Access Compliance Report

Public Rights-of-Way

Intersection ID: 46783	Main Street: WINTER_VIEW_CT	Cross Street: DOMINION_VILLAGE_DR	Location: SW
ADA ID: 493DB2779809	Ramp Type: PerpDiag	Initial Pass/Fail: Fail	Overall Compliance: No
Severity Score: 12.5			
Codes/Mitigation Info/Possible Solution		Field Measurements/Component Compliance

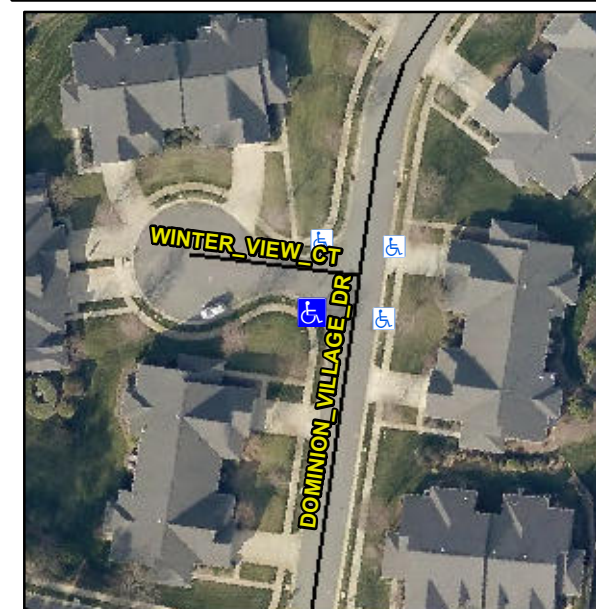
Not Found, R304.2.2

Compliance	Description	Data	Compliance	Description	Data
N/A	Ramp Length (in)	49.0	No	Ramp Slope (%)	10.0
Yes	Ramp Width (in)	48.0	Yes	Ramp XSlope (%)	0.1
N/A	Flare Type LT	N/A	N/A	Flare Type RT	N/A
N/A	Flare Slope LT (%)	N/A	N/A	Flare Slope RT (%)	N/A
N/A	Flare Traversable LT?	N/A	N/A	Flare Traversable RT?	N/A
N/A	Landing Length (in)	N/A	N/A	DWS Provided?	N/A
N/A	Landing Width (in)	N/A	N/A	DWS Contrast?	N/A
N/A	Landing Slope (%)	N/A	N/A	DWS Length (in)	N/A
N/A	Landing X Slope (%)	N/A	N/A	DWS Full Width?	N/A
N/A	Landing Curb? (Y/N)	N/A	N/A	DWS Offset (in)	N/A
N/A	Shared Landing?	N/A			
N/A	Gutter Ponding?	N/A	N/A	Gutter Slope (%)	N/A
N/A	Gutter Lip Ht (in)	N/A	N/A	Gutter X Slope (%)	N/A
N/A	Painted X Walk1?	No	N/A	Painted X Walk2?	No
	X Walk 1 Direction	To E		X Walk 2 Direction	To N
N/A	X Walk 1 Width (in)	N/A	N/A	X Walk 2 Width (in)	N/A
	X Walk 1 Slope (%)	3.6		X Walk 2 Slope (%)	1.1
	X Walk 1 X Slope (%)	0.9		X Walk 2 X Slope (%)	3.3

Remove & Replace Curb Ramp With Two New Directional Ramps or Equivalent.
